Product Change Notice (PCN)

PCN Number: PCN-0456183R-01

Product(s) Affected: SJ-3502-SMT-TR

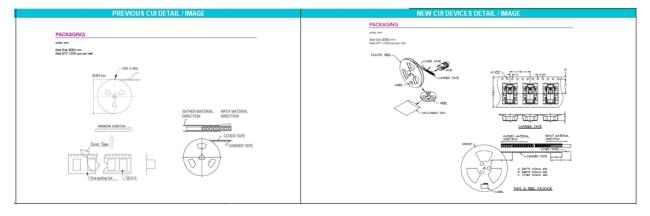
Description of Change: New Factory Location. Product re-engineered for improved manufacturability and production yield. See image below for reference and check CUI Devices website for updated drawing. Cosmetic differences may be visible and not affect the form fit and function of the product.

PREVIOUS CUI DETAIL / IMAGE			NEW CUI DEVICES DETAIL / IMAGE				
DESCRIPTION MATERIAL	PLATING/COLOR	-	DESCRIPTI	ON MATERIAL	PLATING/	COLOR	_
terminal 1 stainless steel	silver	-	terminal 1	stainless steel	silver over	r nickel	_
terminal 2 copper alloy	silver	_	terminal 2	copper alloy	silver over	r nickel	_
terminal 3 copper alloy	silver	_	terminal 3	copper alloy	silver over	r nickel	_
housing PA6T (UL94V-O)	black	-	housing	PA10T (UL94V-0)	black		-
SOLDERABILITY parameter conditions/description	min typ max	units	SOLDERABILITY	conditions/description	min ty	p max	units
reel storage 10-30°C, <70% humidity reflow soldering' see reflow profile	255 260	3	reel storage	at relative humidity <80%	man vy	40	"C
renow societing set renow profile drying conditions [#] parts in reel: bake at 110°C for 4 hours parts removed from reel: bake at 110°C for 4 hours	200 200		reflow soldering ²	see reflow profile	255 26		°C
